## MEMORANDUM

**DATE:** March 4, 2026  
**TO:** Tara Vasicek, City Administrator  
**FROM:** Richard J. Bogus, City Engineer  
**RE:** Sock Pond Addition – Preliminary Plat

**PRELIMINARY PLAT**  
**SOCK POND ADDITION**  
 Lots 3-12 all in K&S Subdivision, part of the Northeast 1/4 of the Southeast 1/4 of Section 23, T17N, R1W of the 6th P.M., Platte County, Nebraska.

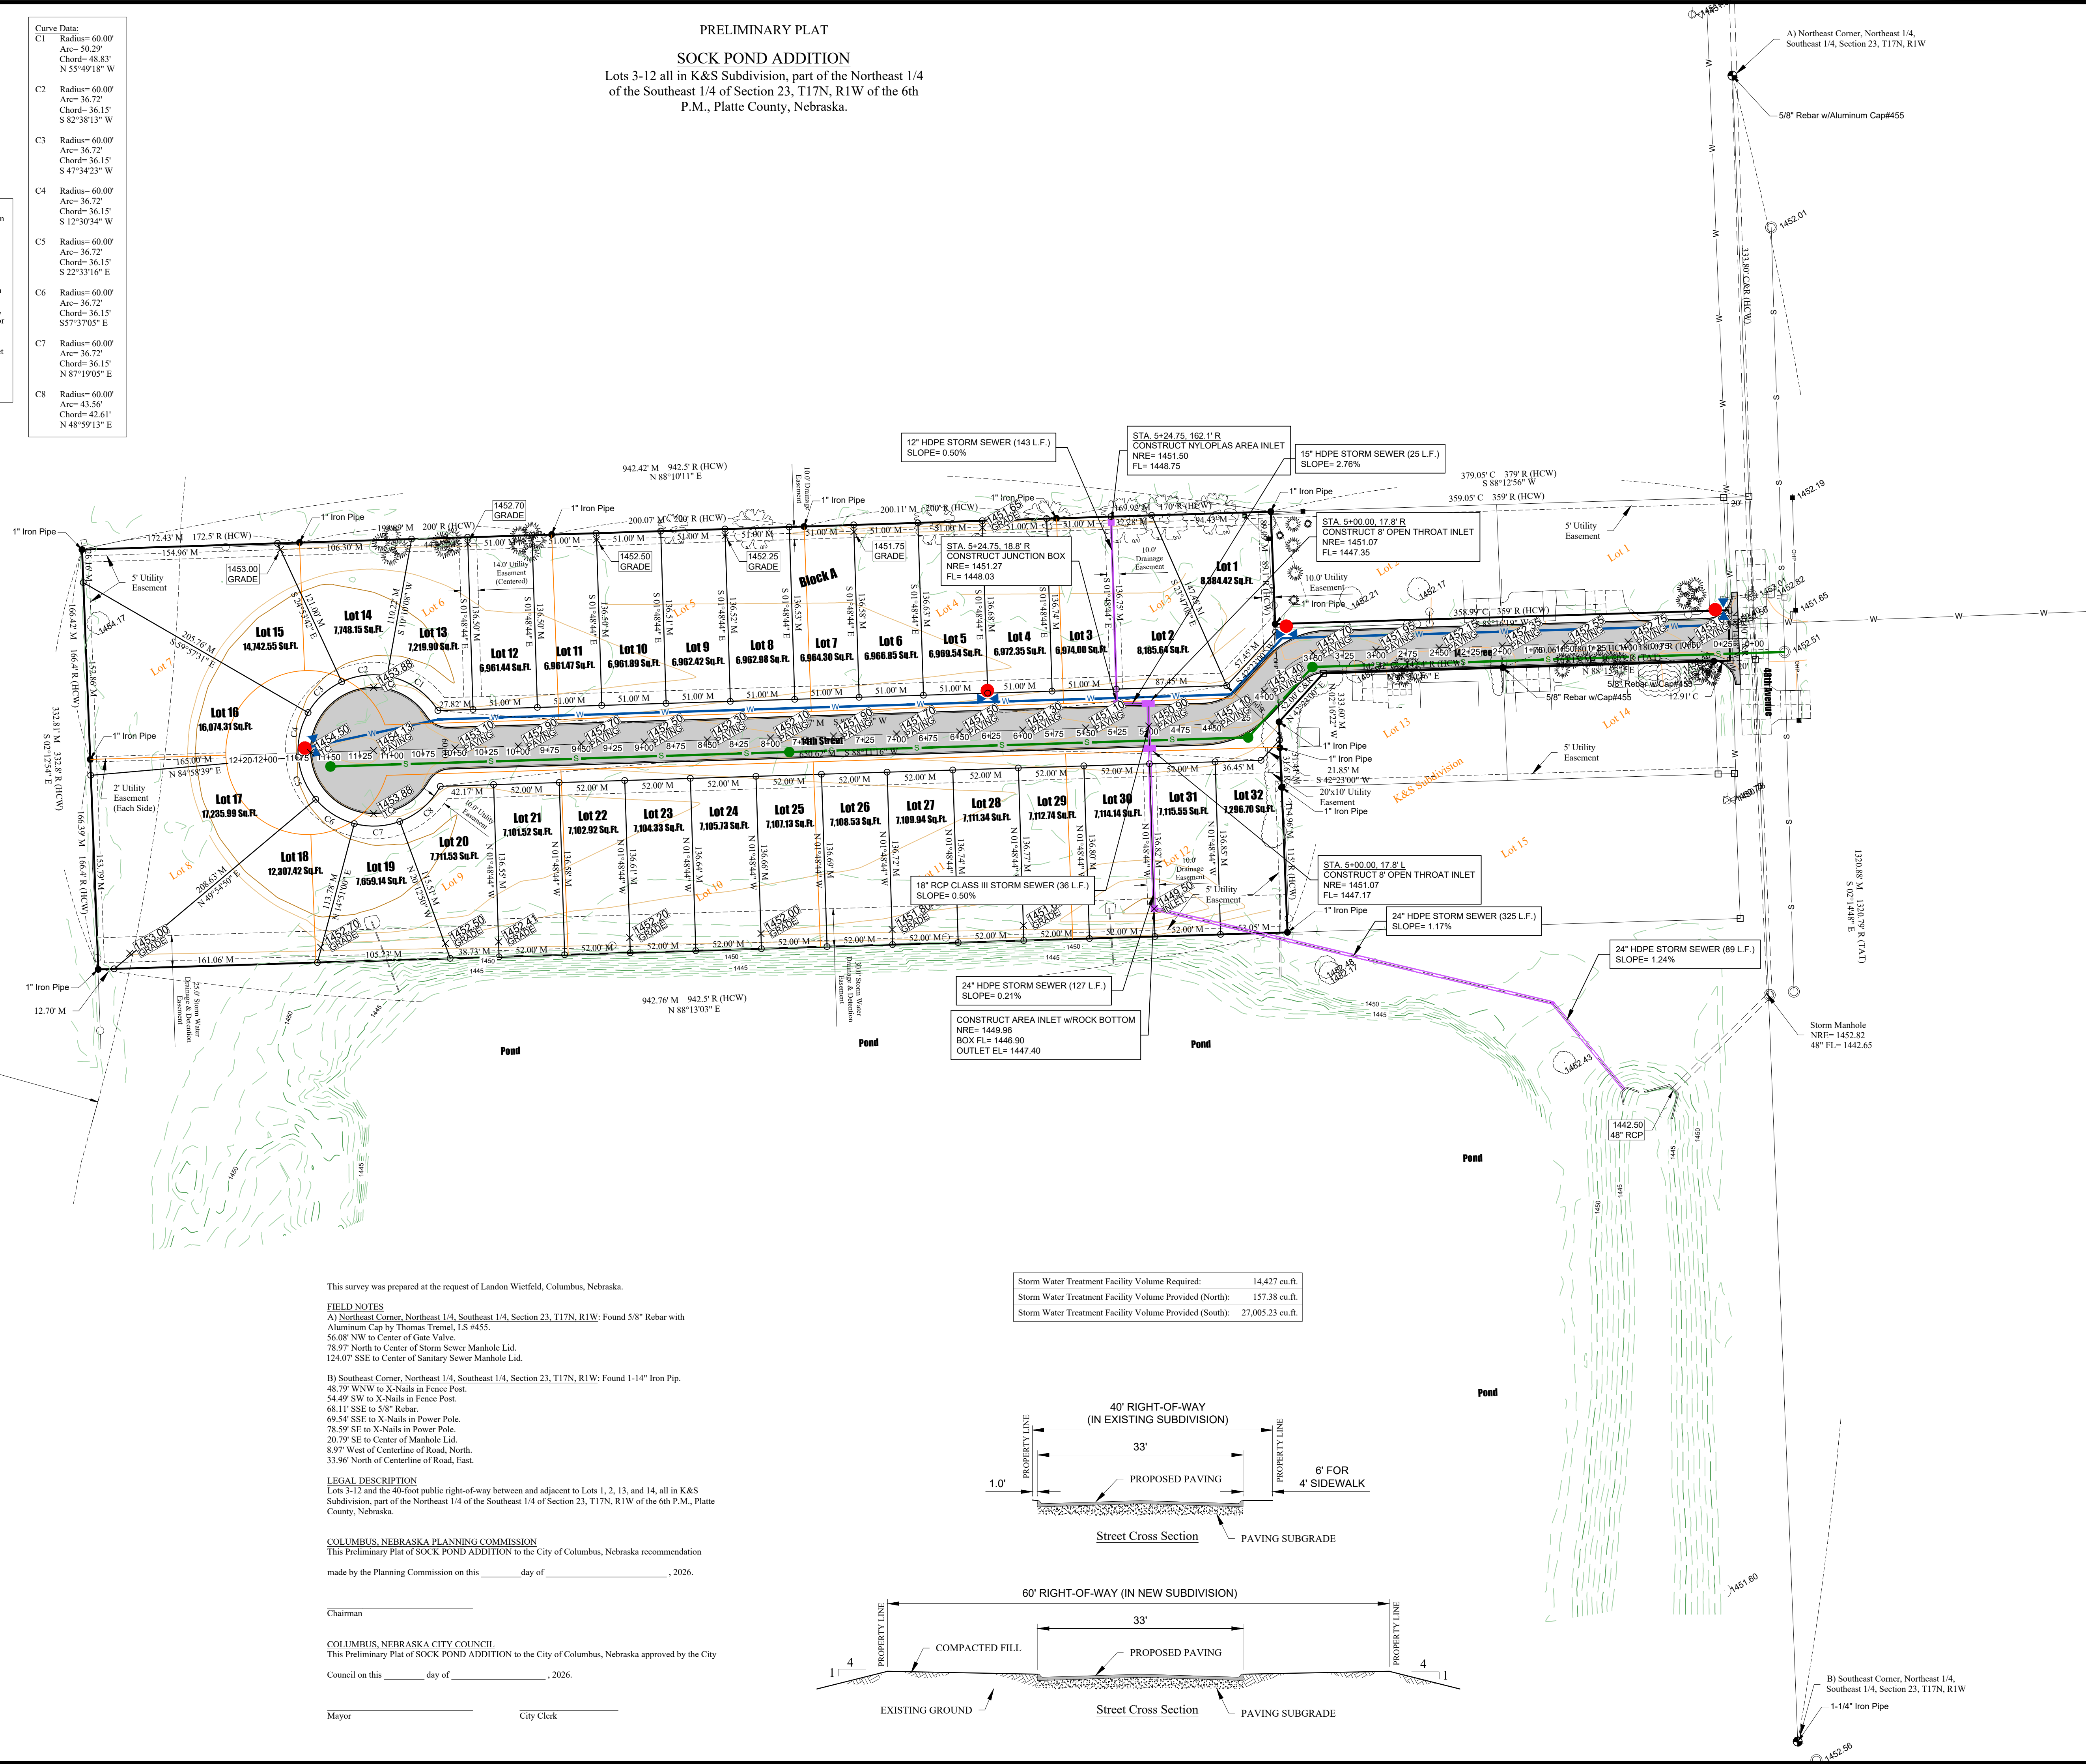
I recommend the approval of the preliminary plat of Sock Pond Addition and the request for waiver of subdivision regulation for length of cul-de-sac to exceed 350 feet, as it is amendable with the land use and is in accordance with the Columbus Land Development Ordinance.

The addition consists of 32 lots for residential use. It will be voluntary annexed and rezoned as part of the final plat process. Public improvements include a street with a cul-de-sac, storm sewer, water and sanitary sewer. The storm sewer treatment facility will utilize both the rear of Lots 21-32 in Block A and the City's storm water pre-treatment to Sock Pond.

A request for waive of subdivision on the length of the cul-de-sac is provided.
